Section 75W Modification Application Environmental Assessment Report

Central Park, Broadway

Modification to Approved Concept Plan MP06_0171 (Mod 10)

November 2014 ■ 14642

Figure 1 – Proposed envelope modifications
Source: Foster + Partners + JBA

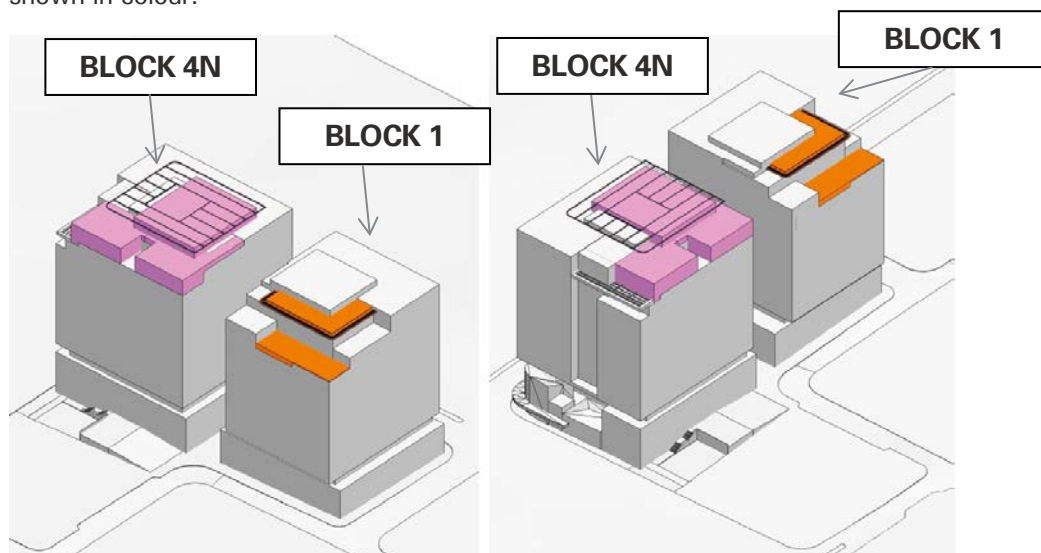
The modification involves changes to the massing of Block 1 and Block 4N, removing the link bridge between the two blocks to allow them to be developed as two independent buildings with different uses. The proposed massing modifications also look to address the change to the intended use including separation distances. **Figure 1** below identified the proposed massing variations shown in colour.

Figure 3 – Proposed Block 1 + 4N Massing – (Mod 10) - north
Source: Foster + Partners

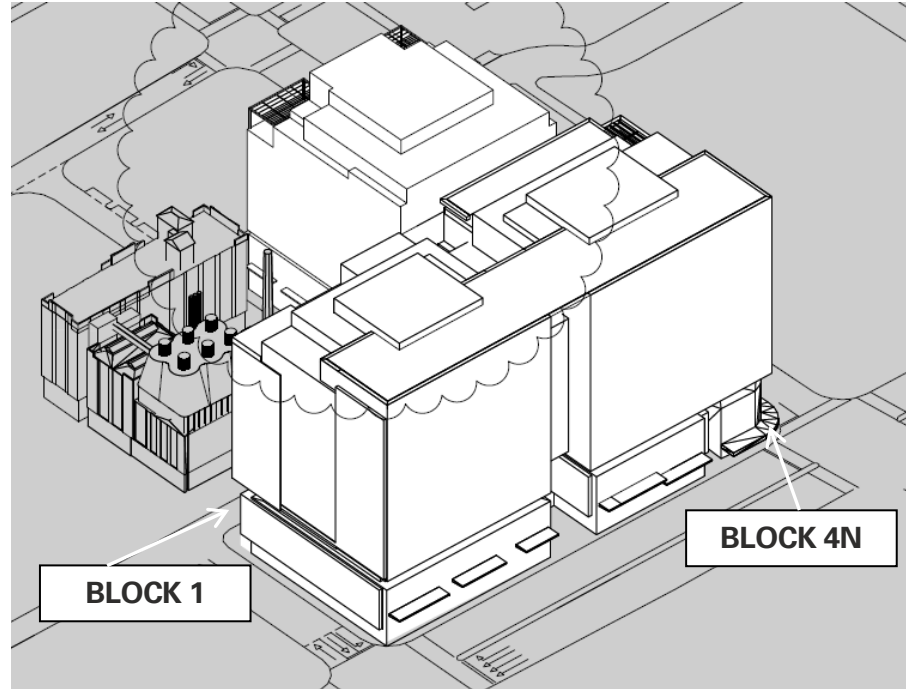
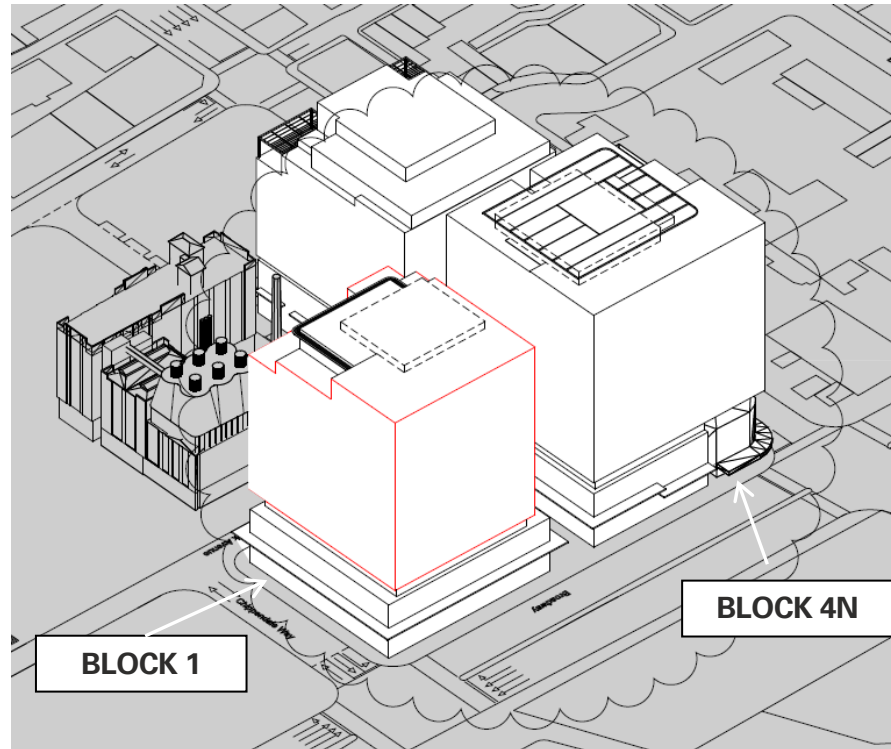
The proposed amendments to be Block 1 building envelope primarily relate to the change in building massing, as well as a removal of the link bridge to Block 4N. The ground floor entry locations and vehicle entry points are not proposed to be further amended from MOD 9. The proposed amendments are shown below in **Figures 2** and **3**.

Figure 5 – Proposed Block 1 + 4N Massing – (Mod 10) - south
Source: Foster + Partners

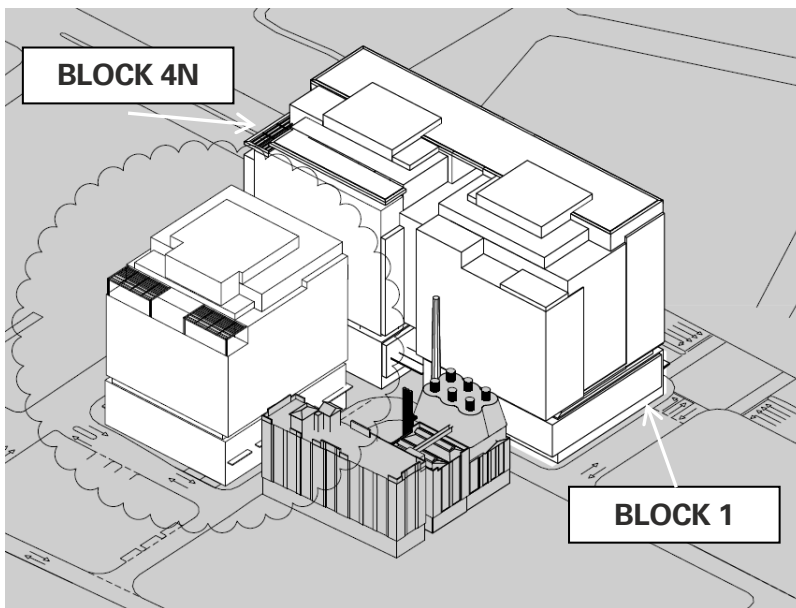
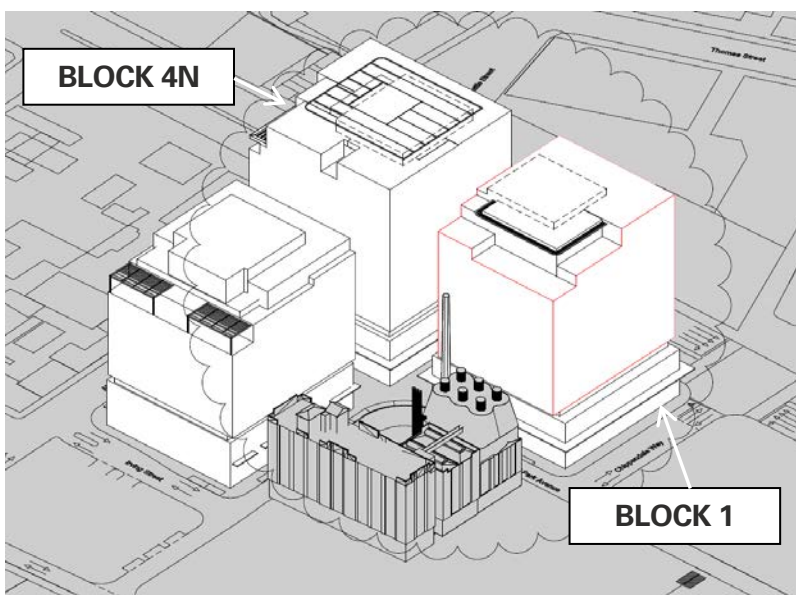
The revised Concept Plan massing to Block 4N as part of this modification maintains the previously approved volume with minor additions to the southern top of the building. These are included to coincide with the Block 4N SSD application and shown above in **Figure 1**.

The existing (MOD 9) and proposed (MOD 10) envelopes are shown below in **Figures 4** and **5**.

Figure 6 – Overshadowing – 21 March 12pm - Midday
Source: Foster + Partners

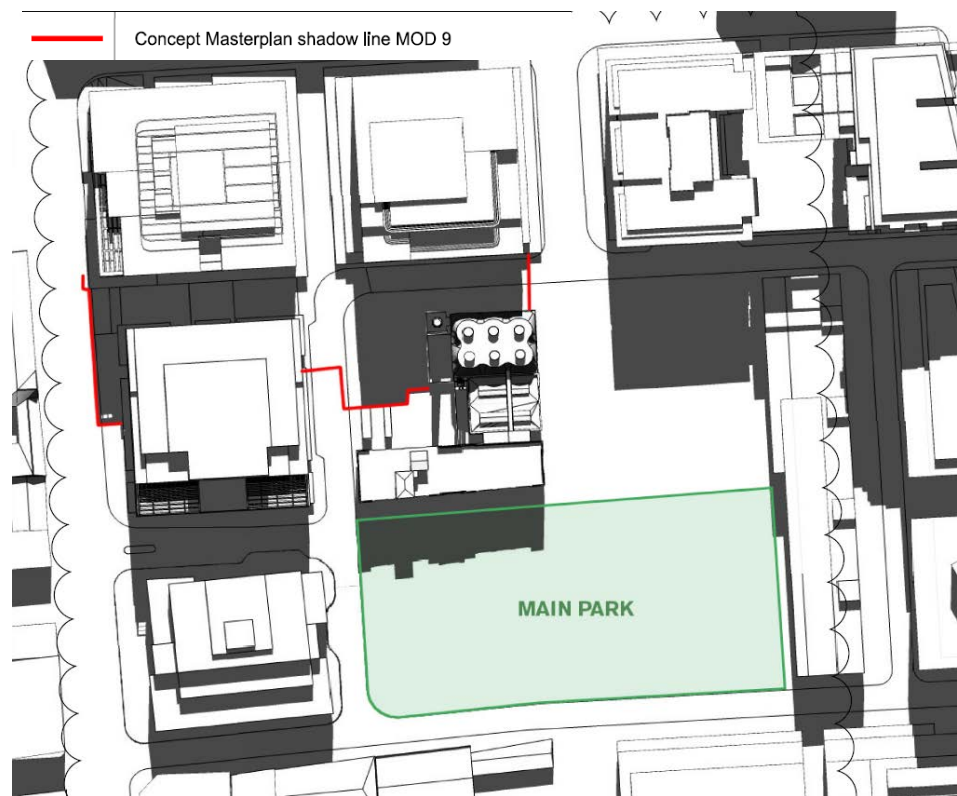
Importantly, as can be seen from the shadow diagrams, the minor variation to the approved concept plan envelope at the rear of Block 4N and Block 1 on the southern side of the building envelope, does not result in any significant overshadowing to surrounding land uses.

Excerpts of the proposed MOD 10 shadow diagrams are provided below in **Figure 6** and **7** which identify a reduction in overshadowing as a result of this modification.
